SURVEY FOR HENRY & MARY AKERS

PART OF THE NE. 1/4 OF
 SEC. 15, T-20, R-18,
 WASHINGTON TWP.,
 RICHLAND CO., OHIO.

Lot Split Application

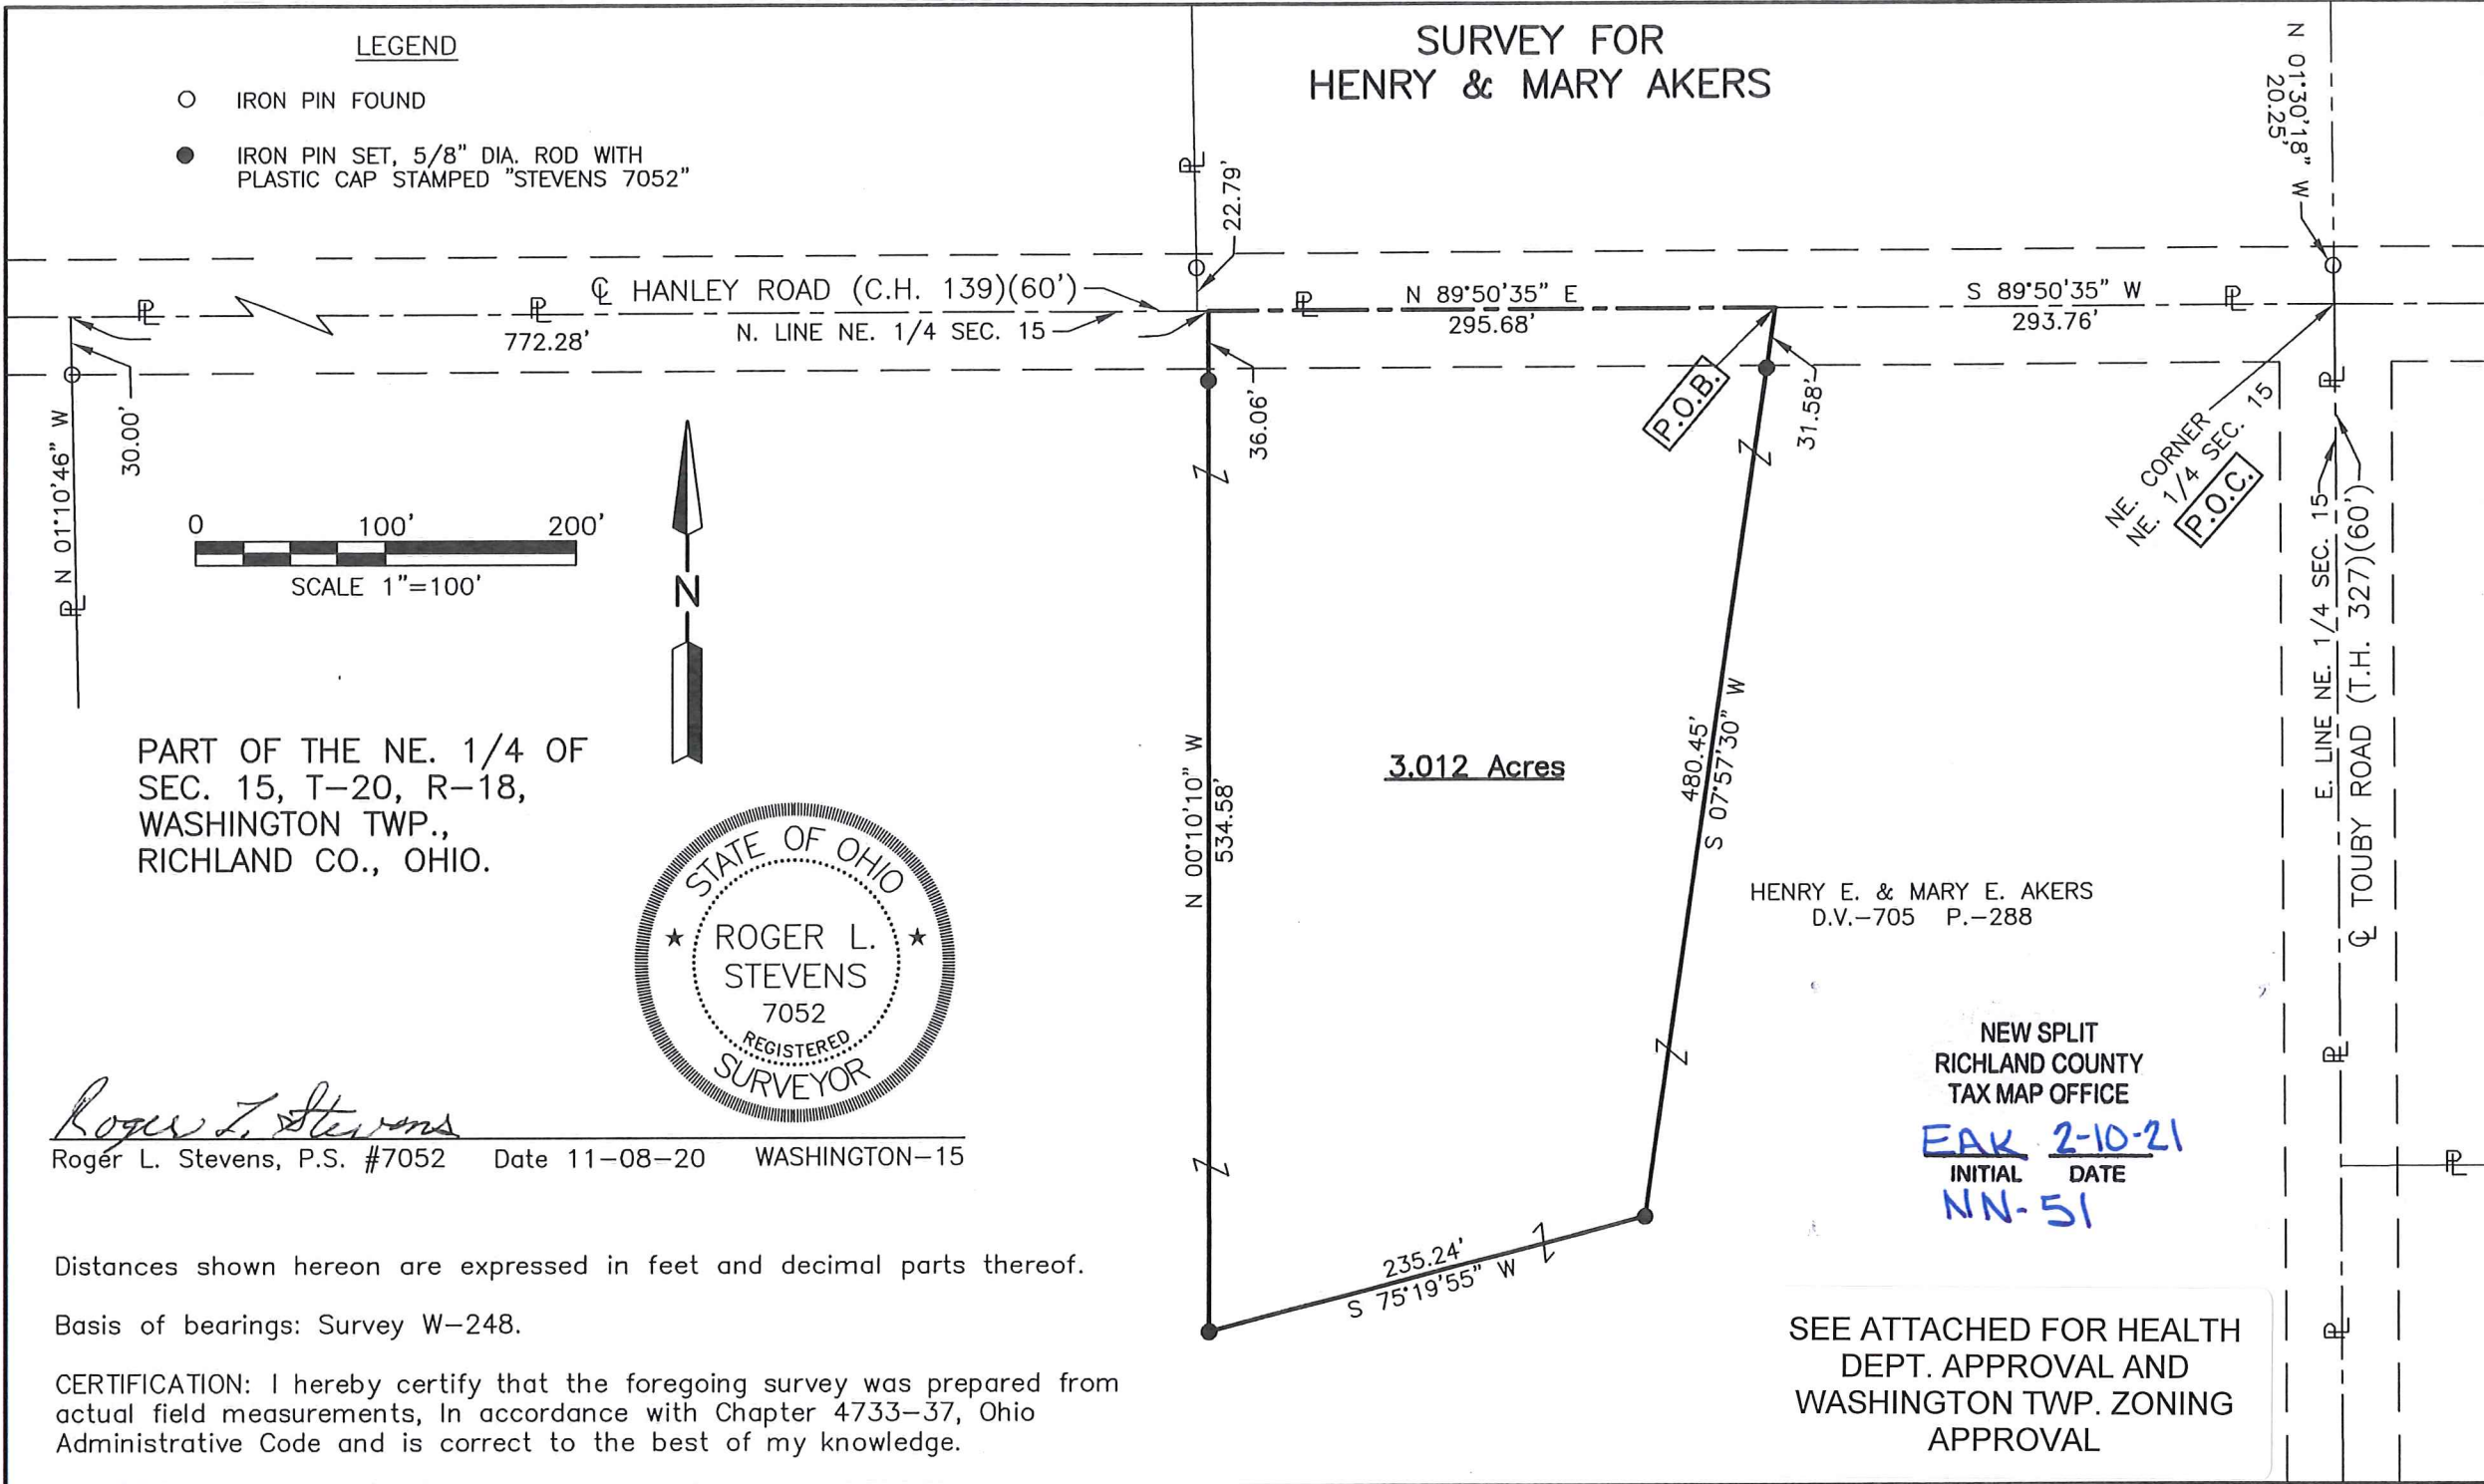
Comments:
PROPOSED INTERCEPTOR DRAIN APPEARS TO DISCHARGE OFF LOT. AN EASEMENT WILL BE NEEDED OR DISCHARGE POINT WILL NEED TO BE LOCATED ON LOT.
